Sheringham Shoal and Dudgeon Offshore Wind Farm Extension Projects

The Applicant's Comments on the Report on Implications to European Sites

Document Reference: 21.2

| Sheringham Shoal and Dudgeon Offshore Wind Farm Extension Projects Examination submission The Applicant's Comments on the Report on the Implications for European Sites (RIES) | |

-  Dudgeon Extension Project Wind Farm Site
-  Sheringham Shoal Extension Project Wind Farm Site
-  Special Protection Area (SPA)

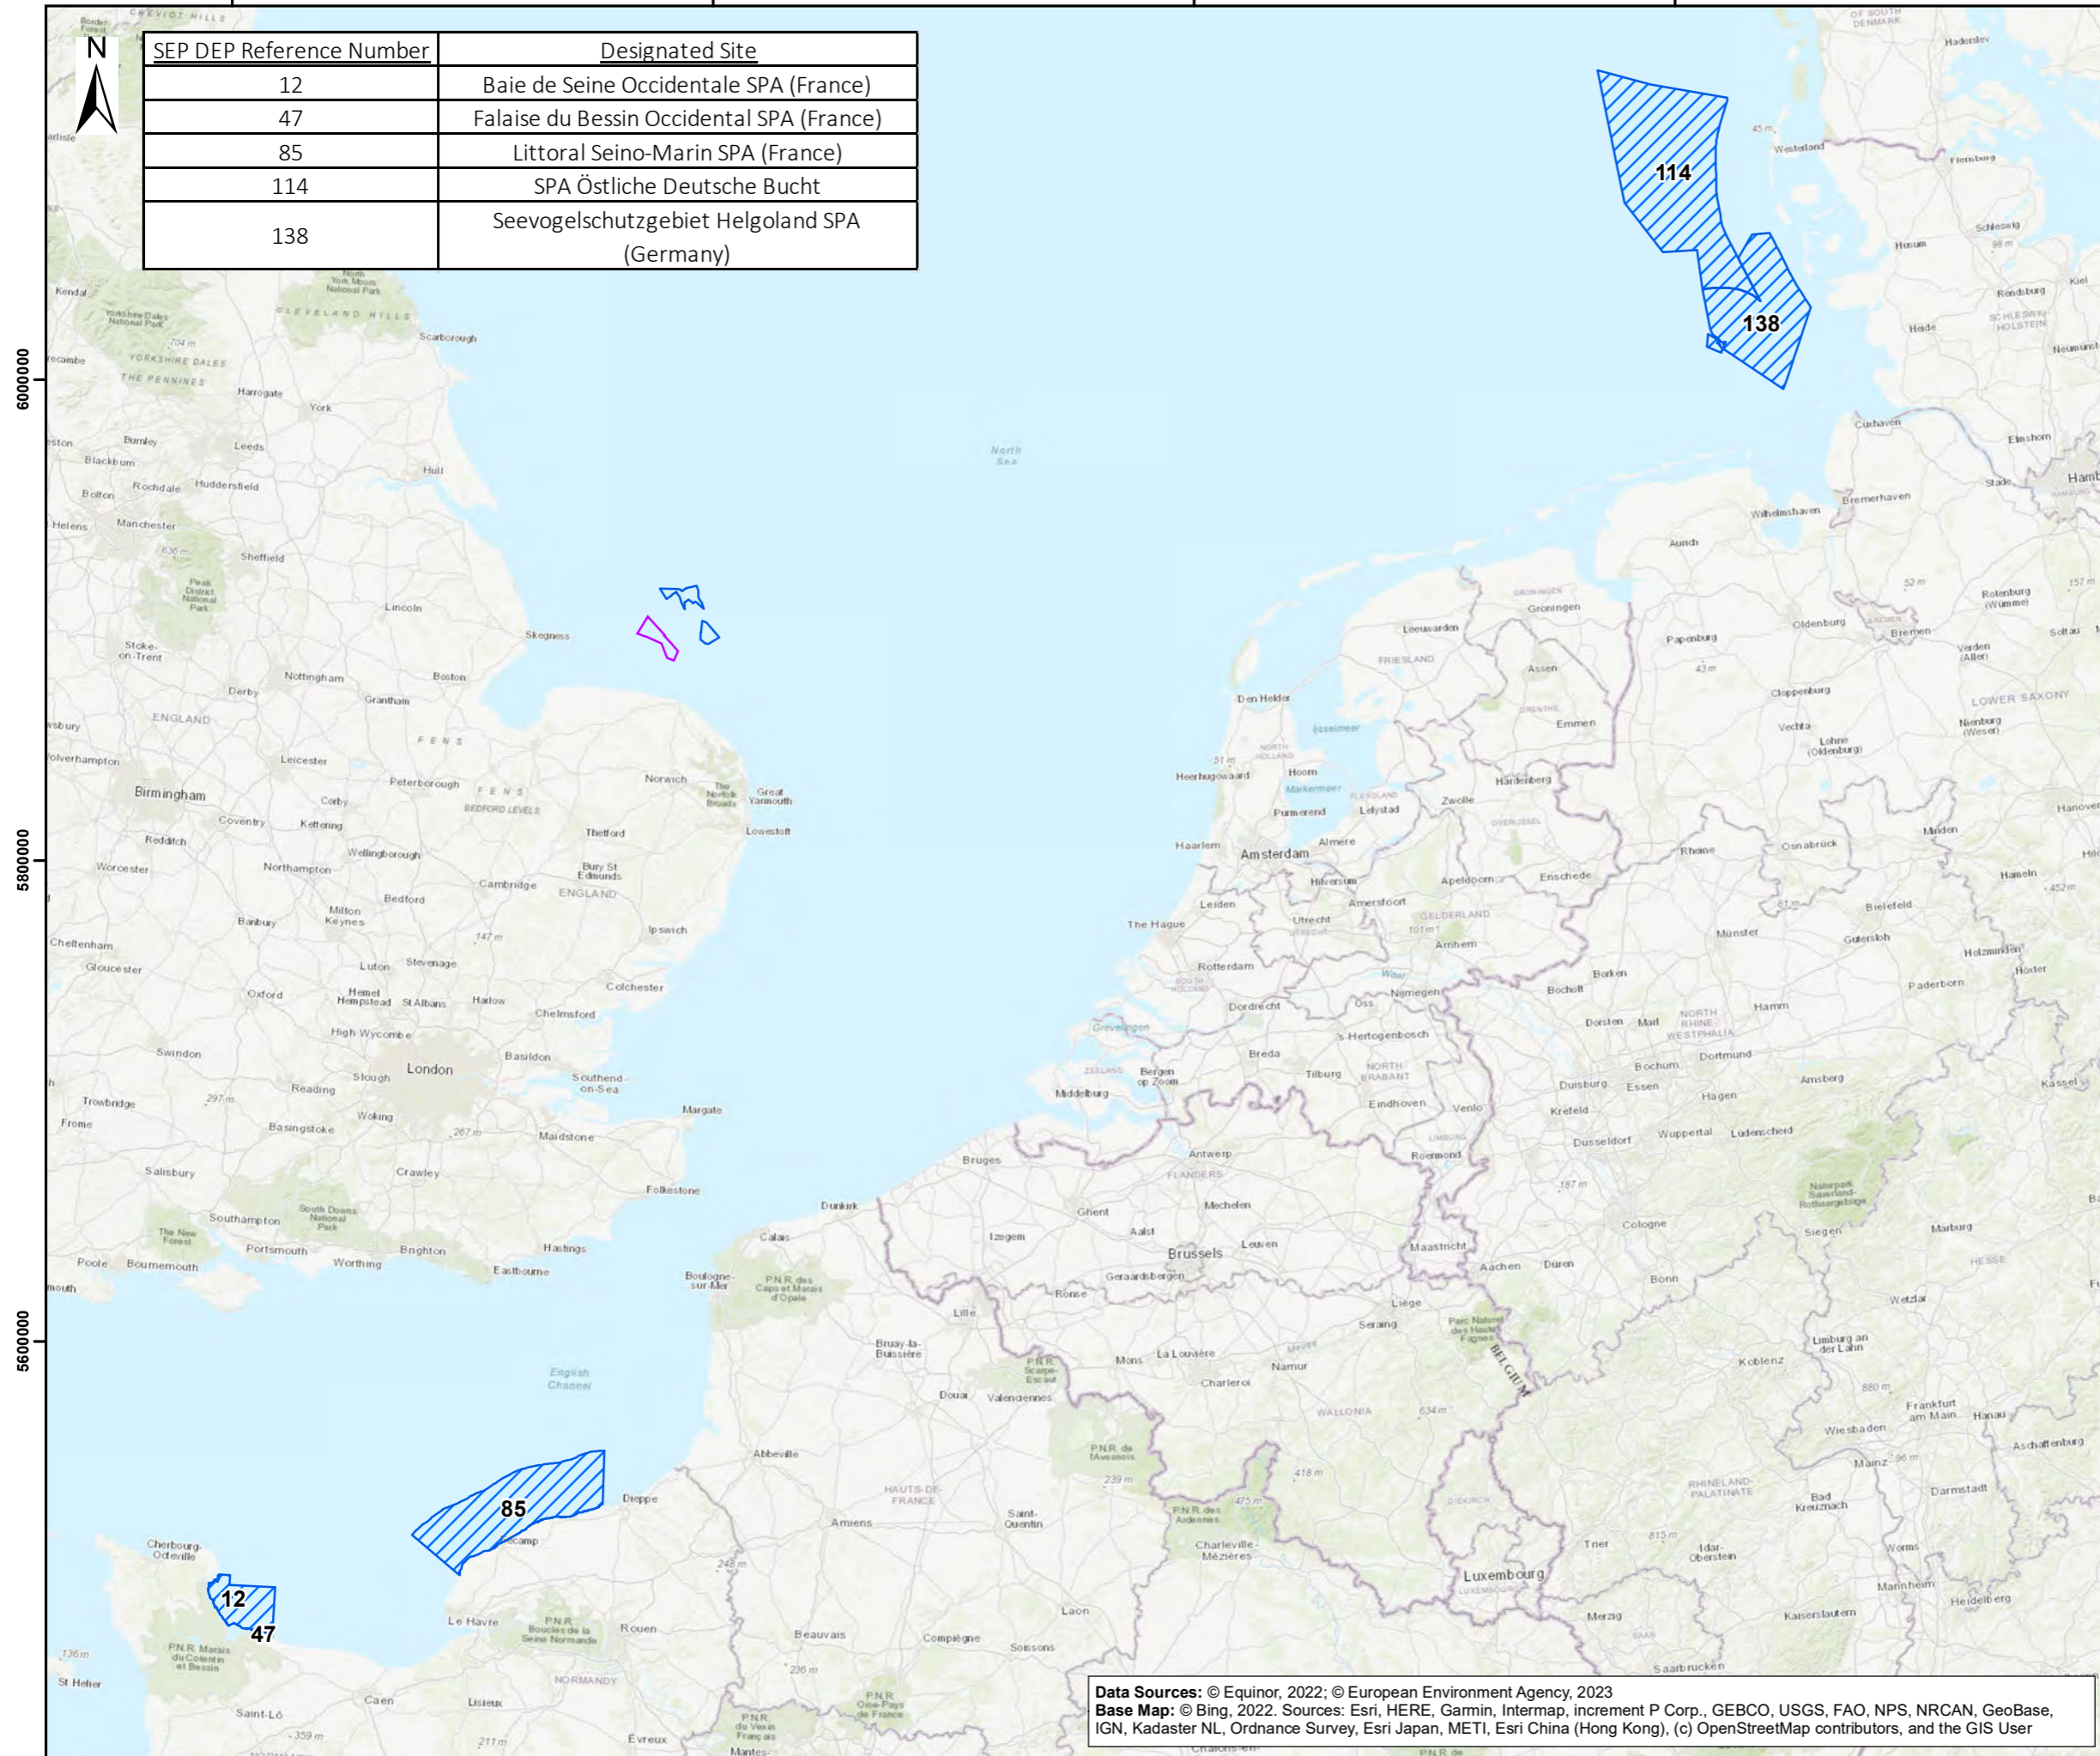
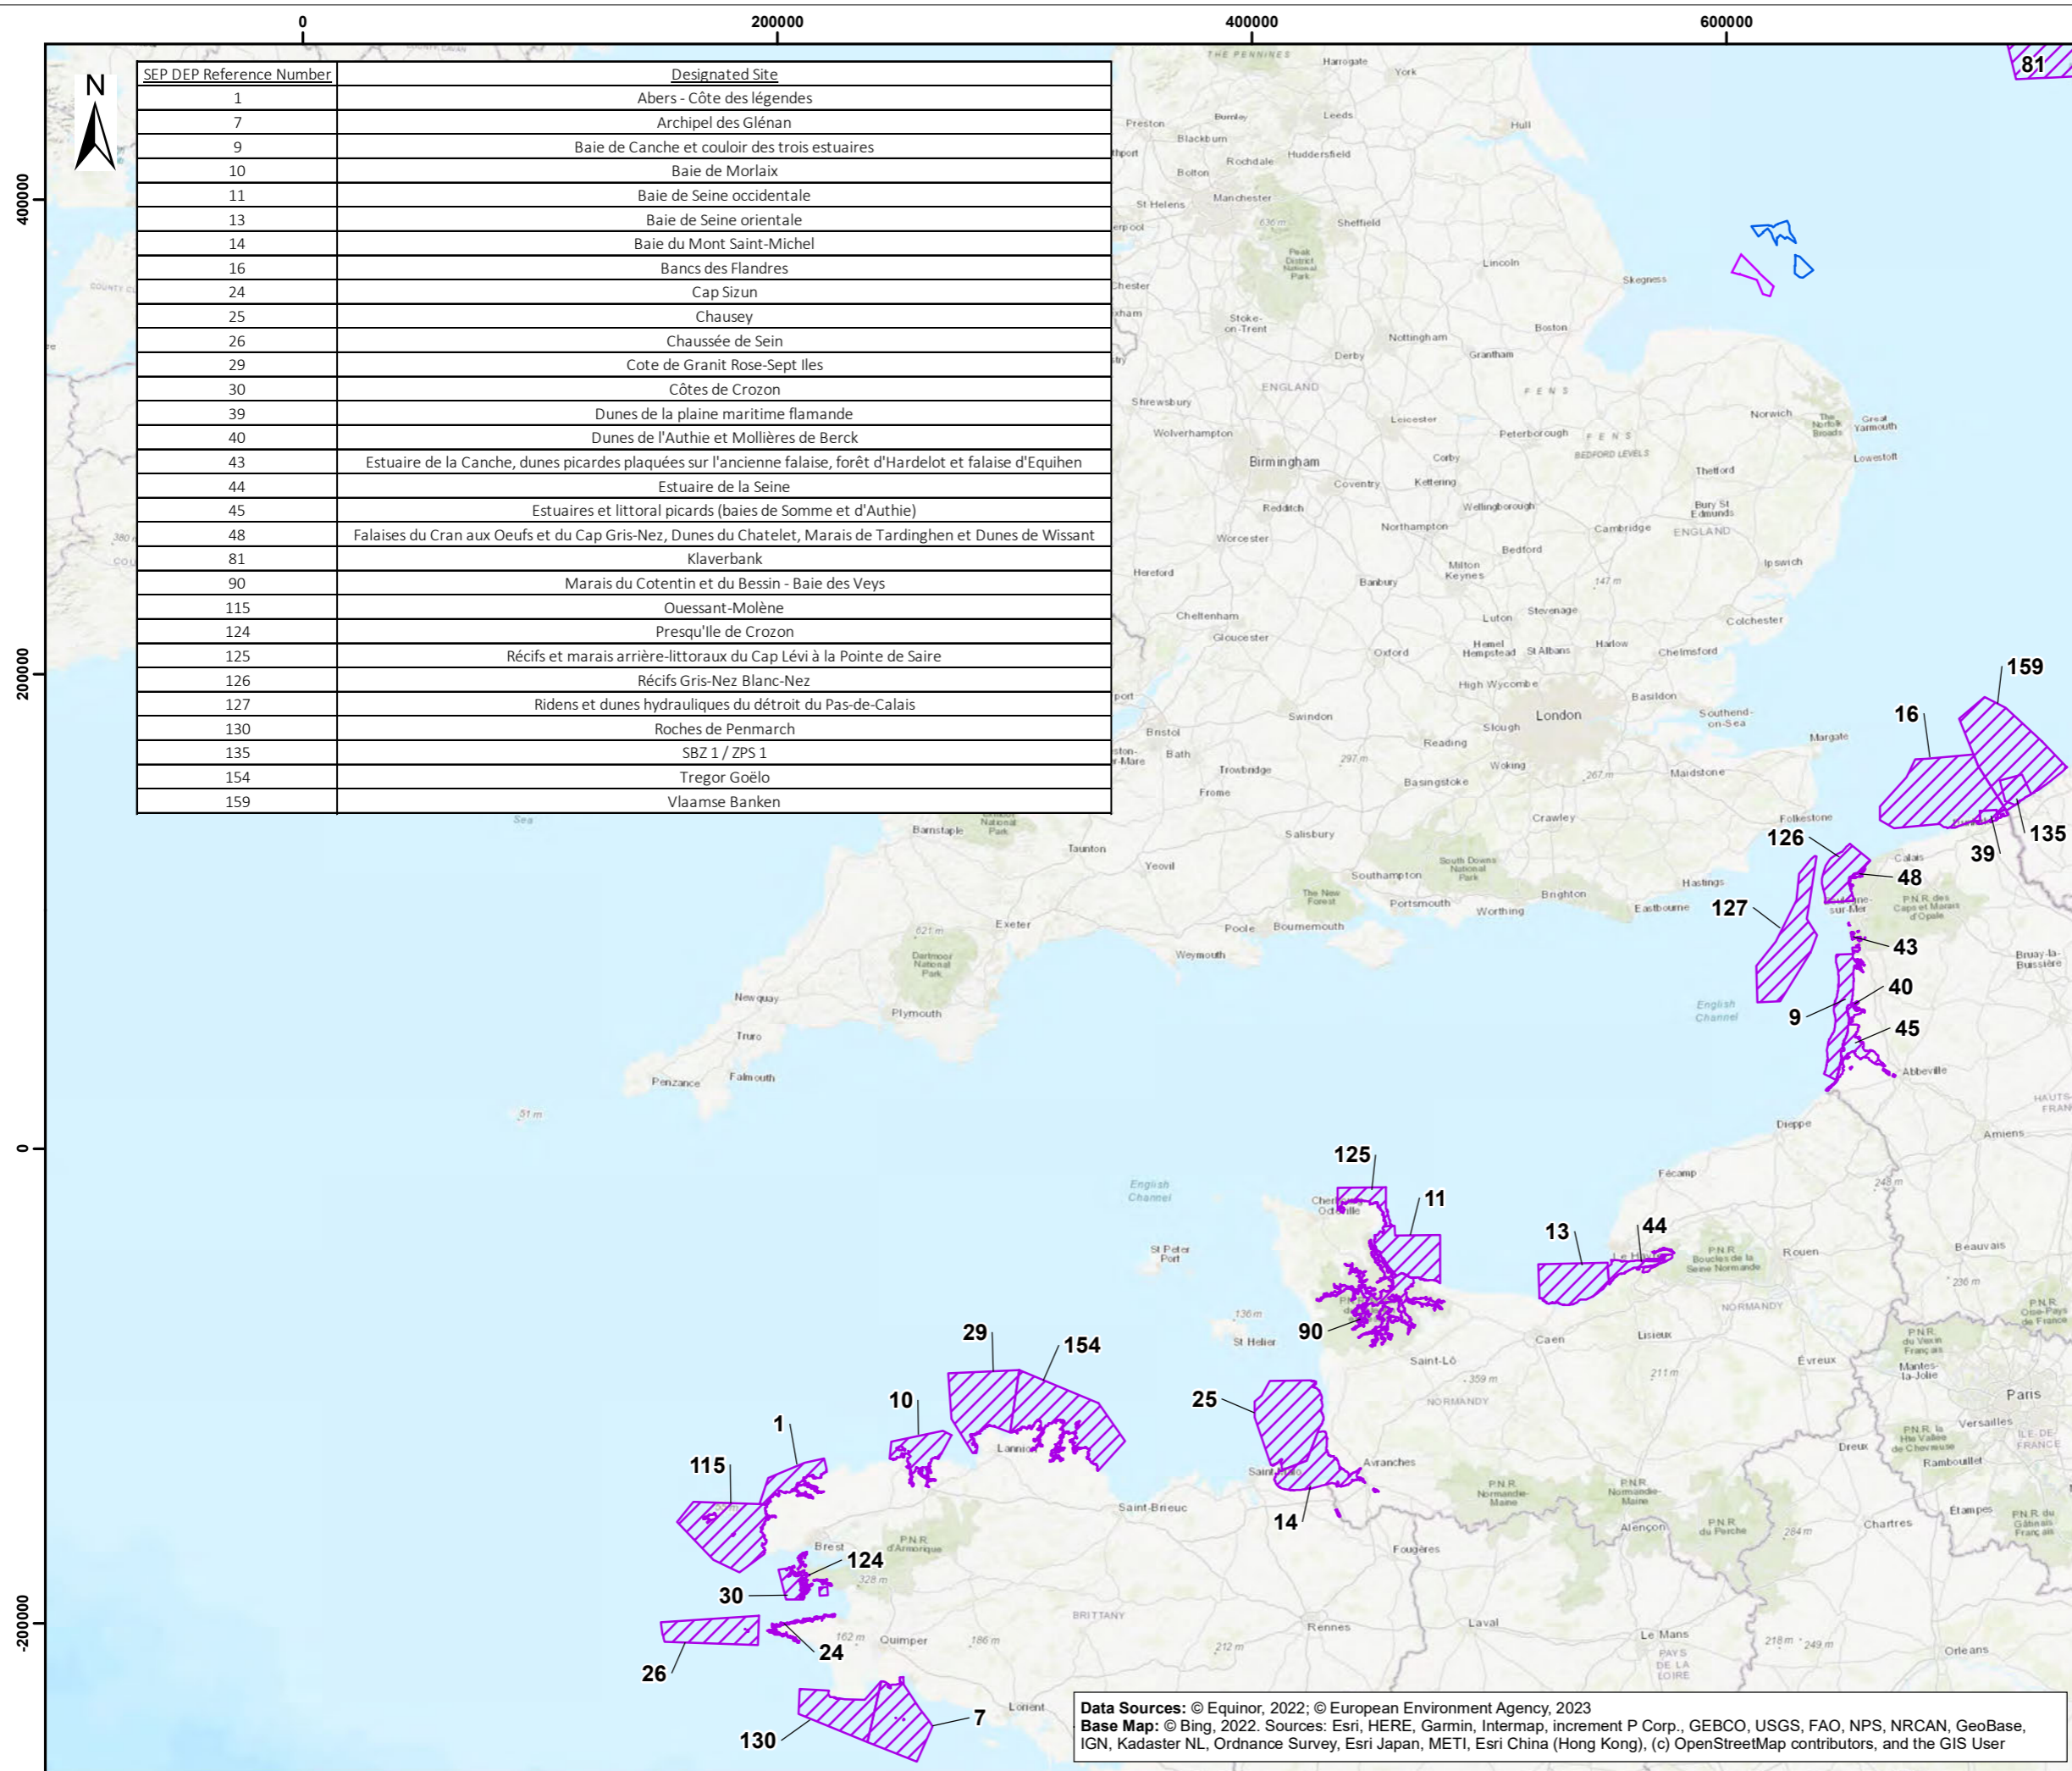
| RIES ID | RIES Question / Extract | Question Addressed to | Applicant Response |
|---------|---|-----------------------|--|
| RIES-Q1 | The Applicant is requested to provide further clearly labelled figures to show the extent of all European sites considered in the Applicant's HRA assessment in relation to the Proposed Developments, including a figure(s) to show non-UK European sites. | The Applicant | <p>These are provided in Annex I.</p> <p>Due to space limitations each figure is provided as follows:</p> <ul style="list-style-type: none"> • UK SPA AND RAMSAR • UK SAC • EUROPEAN SPA AND RAMSAR • EUROPEAN SAC (France) • EUROPEAN SAC (excluding France) <p>It should be noted that the 'SEP and DEP reference' number shown on each figure corresponds to those within Table 3-2 of the Habitats Regulations Assessment Screening Matrices (Revision B) [REP4-009].</p> |
